**72+COLLINS HOTEL &
CONDOMINIUM**7118 - 7140 COLLINS AVENUE & 7121 - 7145 HARDING AVENUE
MIAMI BEACH - FLORIDA 33141

Permit Revisions

Luis O. Revuelta
AR-0007972**ZONING
PRESENTATION**Date
04.06.2018Scale
AS SHOWNProject No.
1729

A-102**PROPOSED****LEVEL 2 - PARKING BOH**

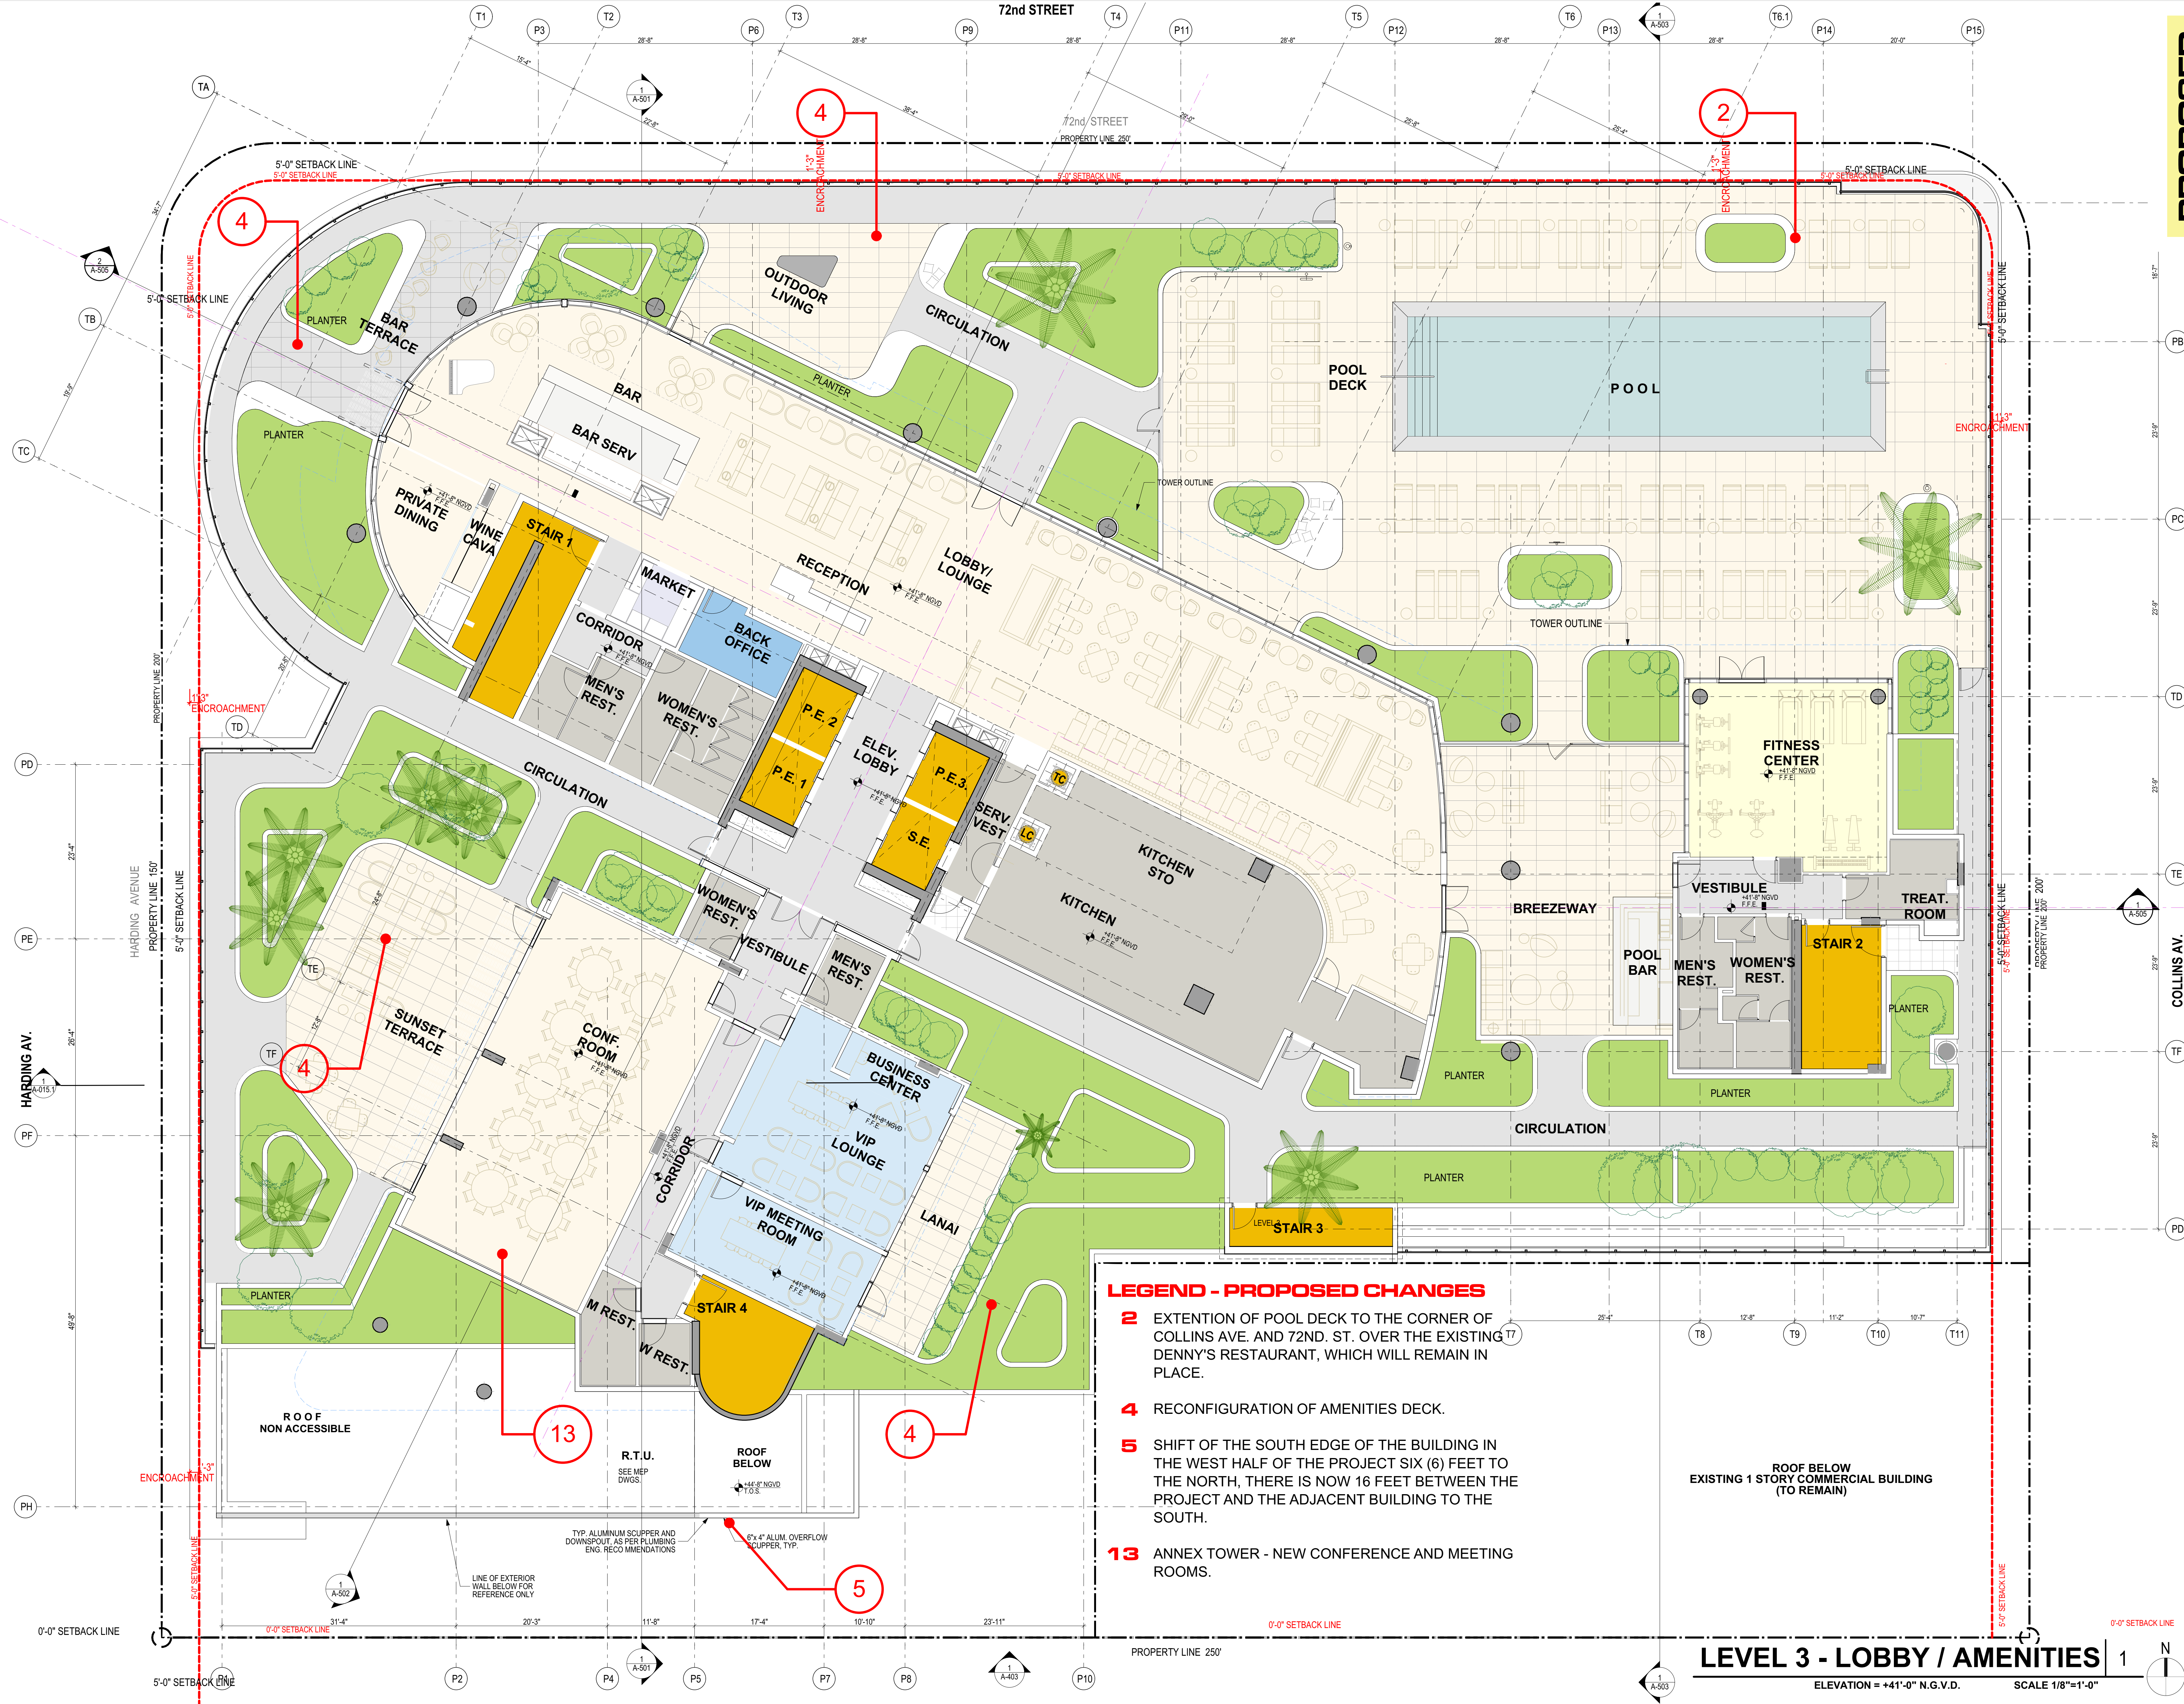
- 2** EXTENSION OF POOL DECK TO THE CORNER OF COLLINS AVE. AND 72ND. ST. OVER THE EXISTING DENNY'S RESTAURANT, WHICH WILL REMAIN IN PLACE.
- 4** RECONFIGURATION OF AMENITIES DECK.
- 5** SHIFT OF THE SOUTH EDGE OF THE BUILDING IN THE WEST HALF OF THE PROJECT SIX (6) FEET TO THE NORTH, THERE IS NOW 16 FEET BETWEEN THE PROJECT AND THE ADJACENT BUILDING TO THE SOUTH.
- 13** ANNEX TOWER - NEW CONFERENCE AND MEETING ROOMS.
